IFB No. **23-15 HVAC Upgrades at Hillman, McIntosh, Gregory & Nashold Schools**

RE: **ADDENDUM NO. 2**

RE: **IFB 23-15 ADDENDUM #2**

PROJECT: HVAC Improvement projects:
2301 Hillman Elementary School
2302 McIntosh Elementary School
2400 Gregory Elementary School
2402 Nashold Early Childhood Center

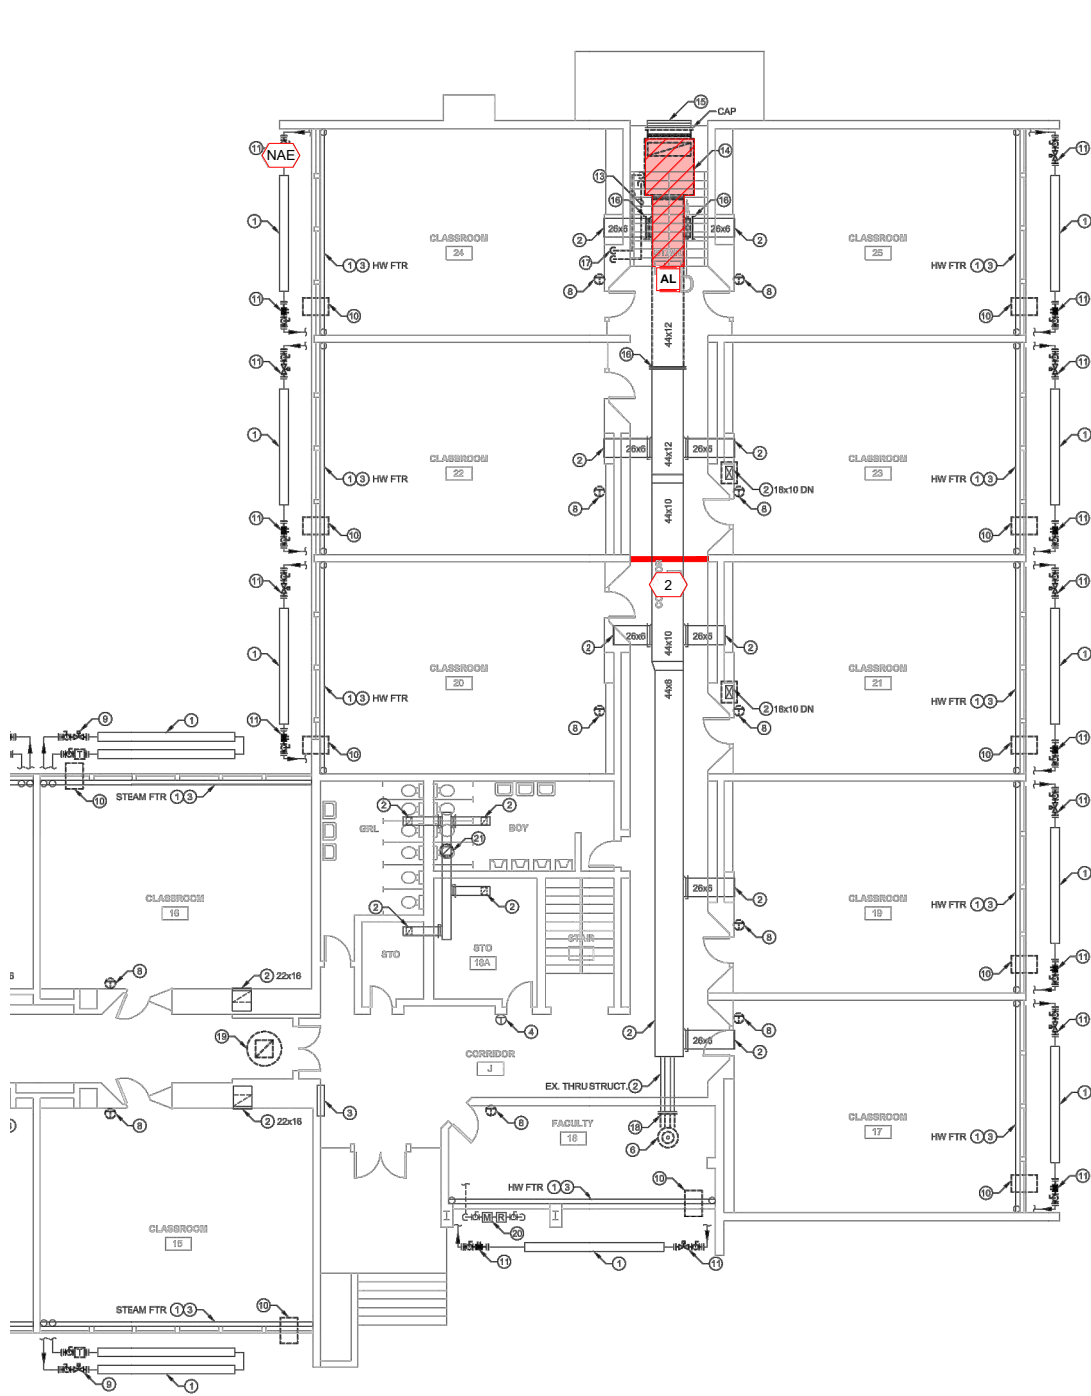
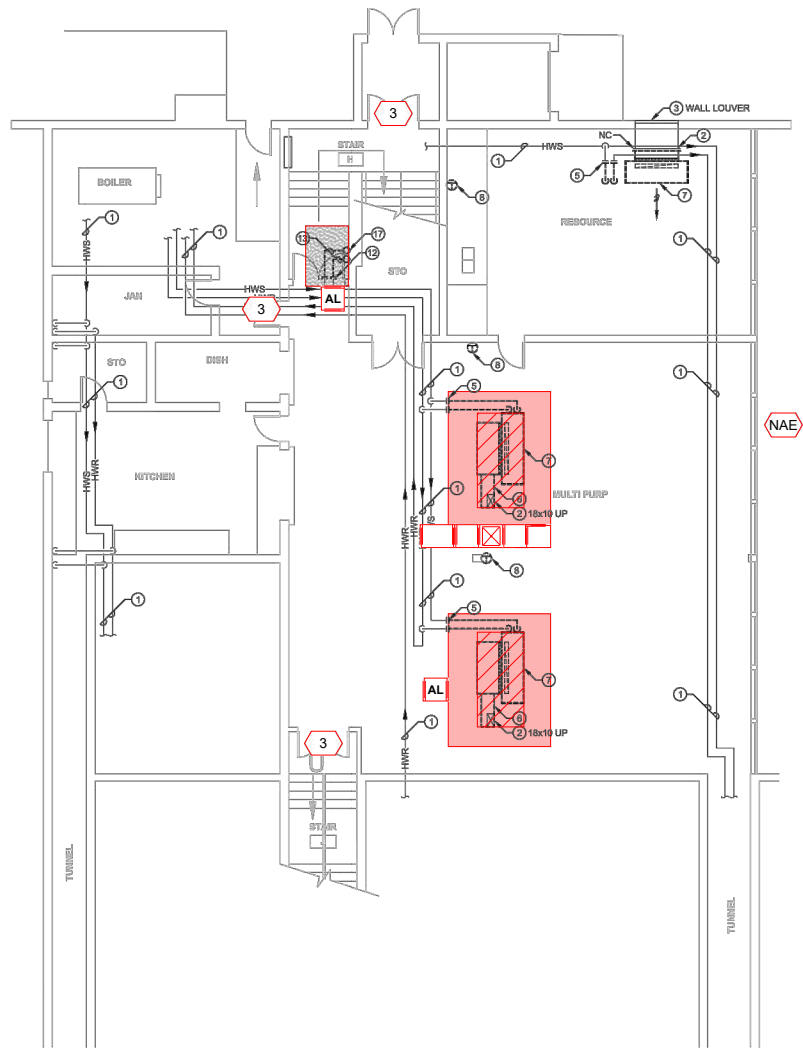
Response: The district can provide asbestos reports. Any abatement work required, will be performed by others. There is no abatement work as part of this bid scope. See attached abatement documents for work performed by others at Nashold and McIntosh.

1. Carnow Conibear abatement at Nashold
2. Carnow Conibear abatement at McIntosh

ASBESTOS ABATEMENT NOTE:
REMOVAL AND DISPOSAL OF ACM PIPE INSULATION
AS INDICATED IN WORK AREAS AND UNIT
VENTILATOR VIBRATION DAMPERS/COLLARS.
WORK SHALL BE CONDUCTED WITHIN A
MINI-ENCLOSURE.
